RETROSPECTIVE PLANNING APPLICATION FOR THE ACCESS TO EXISTING GARAGE AND WORKSHOPS AT SMITHS AT PINWALL (APPLICATION REFERENCE: 25/00444/FUL)

Title: Proposed Changes to Constructed Layout

Road Safety Audit Stage 1

STAGE 1 ROAD SAFETY AUDIT RESPONSE REPORT

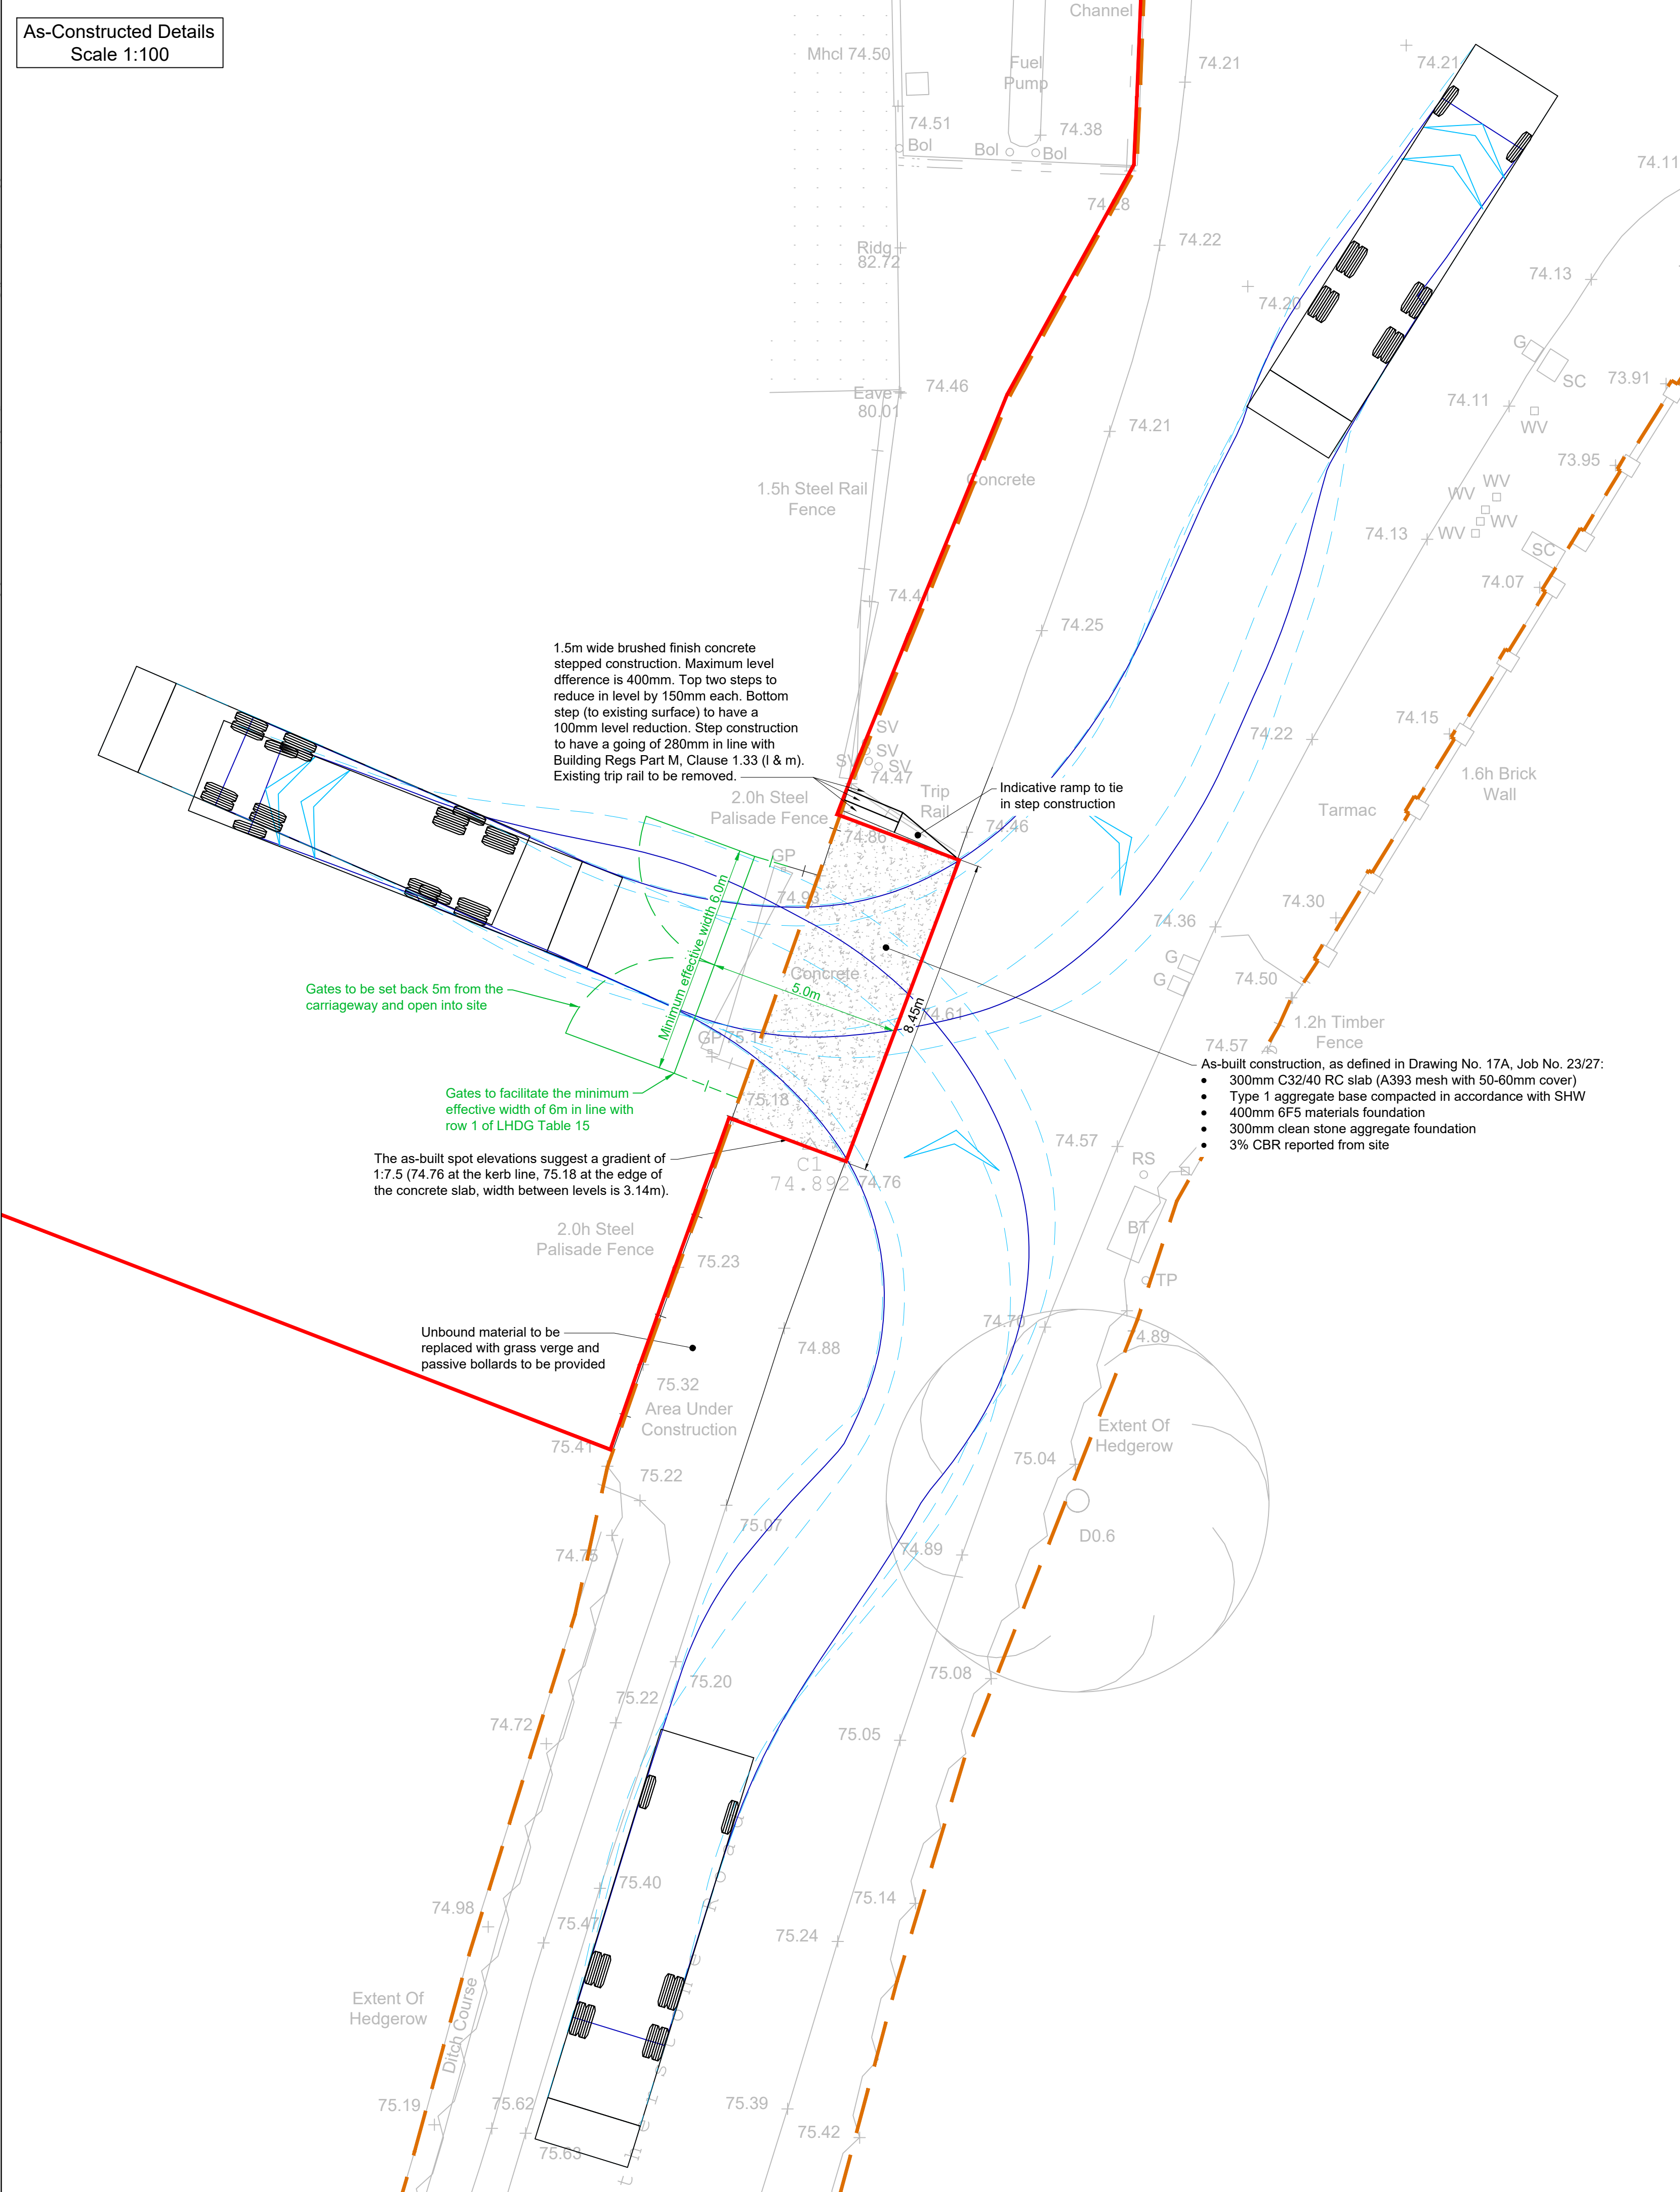
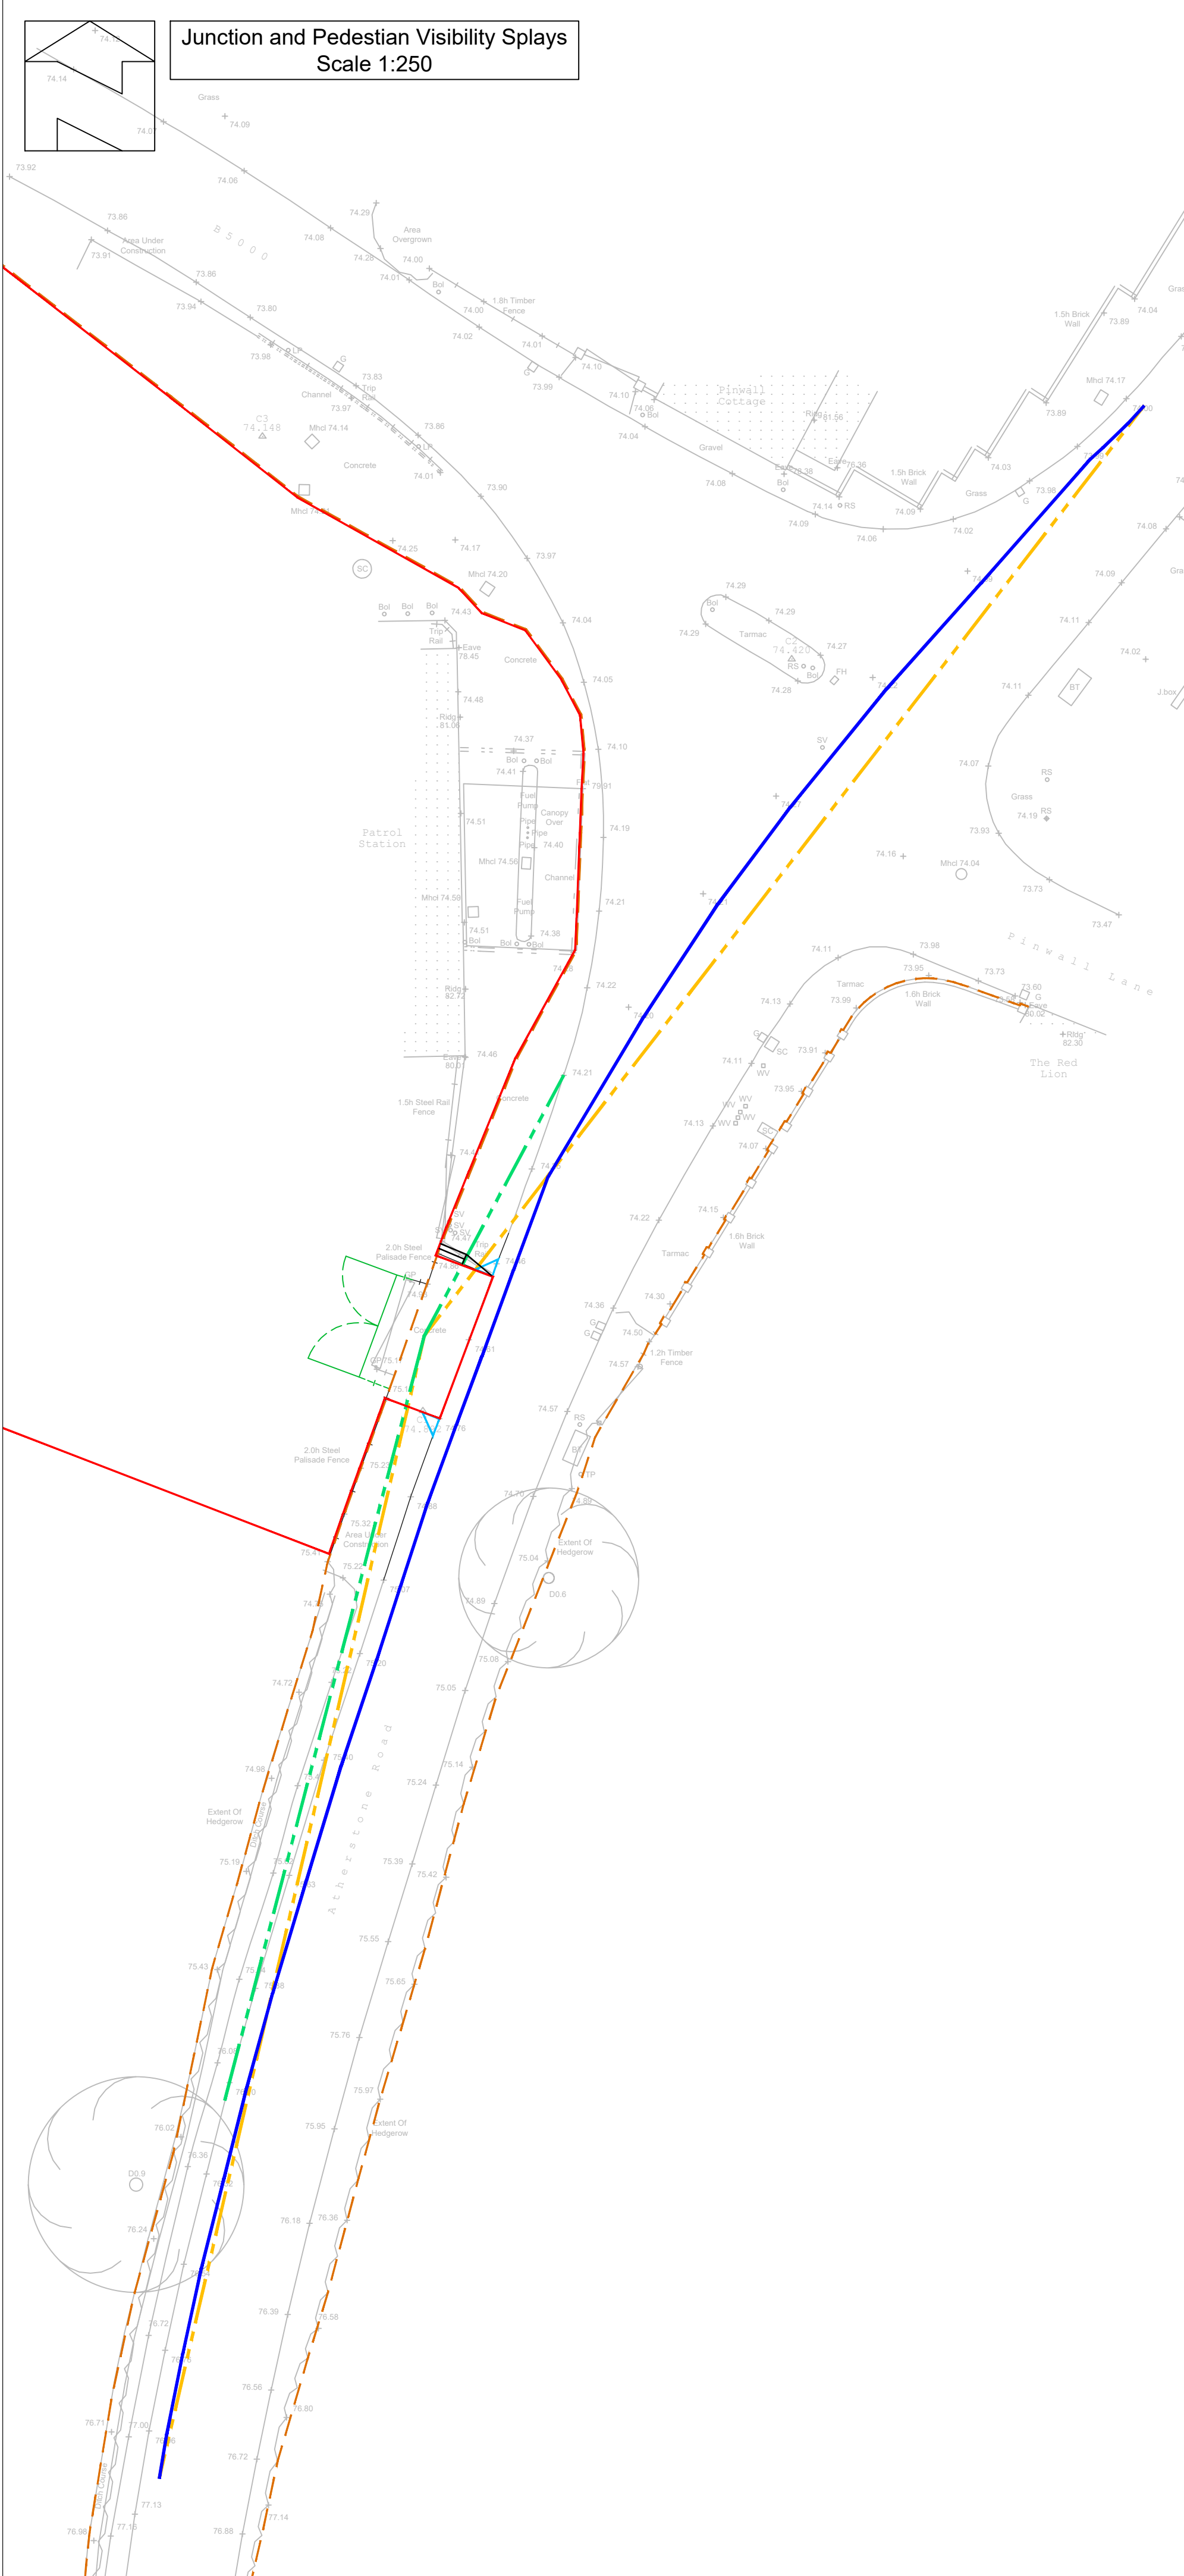
The second problem raised is related to the knee-high rail that is provided to the immediate north of the access which may increase the risk of trips and falls for pedestrians. The recommendation is for the knee-high rail to be removed and to be replaced with a stepped arrangement and a tapered ramp.

As shown within **Appendix C**, the recommendation is accepted and it is proposed to remove the knee rail fence and construct a step/ramp arrangement to provide a safer transition between the existing level difference. **Drawing 3801-ADC-HGN-XX-DR-CH-0111-S4-P06** shows the 2D alignment of the steps as well as the suggested heights and depths of the steps.

LCC have stated within their highway comments that the red line submitted with the application overlaps with the highway boundary. LCC have therefore requested a copy of the public highway is obtained and is enclosed within **Appendix D**.

The LHA have reviewed drawing ADC-HGN-XX-DR-CH-0111 S4 P01 and welcome that the access arrangements align with Table 15 of the LHDG.

Gates should be set-back to allow for the largest expected vehicle on site to be off the highway, any vehicle waiting within the highway in this location would not be acceptable. This could be secured via condition should a positive recommendation be reached.

From the Applicant's submitted location plan (red line plan), included within the Applicants red line is land within the highway boundary. The Applicant is strongly advised to obtain the LHAs formal opinion of the highway extents by contacting the Highway Records and Enquiries team at the LHA via HRE@leics.gov.uk.

Loose aggregate material has been placed in the verge area where previously there was a grass verge. Some vehicle overrun was noted here but it was unclear whether this was related to the access or the petrol filling station. The loose material is likely to be disturbed by vehicle overrun and spread into the main carriageway. This loose material may then be a factor in a loss of control type collision which may be especially a problem for more vulnerable road users such as cyclists or powered two wheelers.

A timber knee rail has been provided, with reflectors for conspicuity. However, it is likely that pedestrians from the commercial site will seek to access the petrol filling station, specifically to use the shop and associated facilities. The knee rail and associated unmade area underneath may increase the risk of trips and falls should pedestrians attempt to step over the knee rail. The knee rail also presents a hazard that less agile pedestrians may walk around, consequently stepping into the main carriageway where they may be hit by passing vehicle. Timber knee rails can also be a roadside hazard for errant vehicles, with rail penetration into the passenger cell of a vehicle increasing the injury severity following a collision.

As shown within **Appendix C**, the recommendation is accepted and the loose aggregate would be replaced with grass verge and would include the addition of passive bollards.

The highway boundary has been overlaid onto **Drawing 3801-ADC-HGN-XX-DR-CH-0111-S4-P06**. As shown, the red line boundary now aligns with the highway boundary but includes the area where the access works have occurred within the highway.

Rev	Date	Description	Dr	Ch
P06	28.05.26	Steps and ramp added	AL	KG
P05	22.05.26	Revised site boundary	KG	-
P04	21.05.26	Revised site boundary	KG	-
P03	20.05.26	Revised site boundary	KG	-
P02	18.05.26	Highway/application boundary added	KG	-
P01	10.03.26	Issued for approval	AL	KG
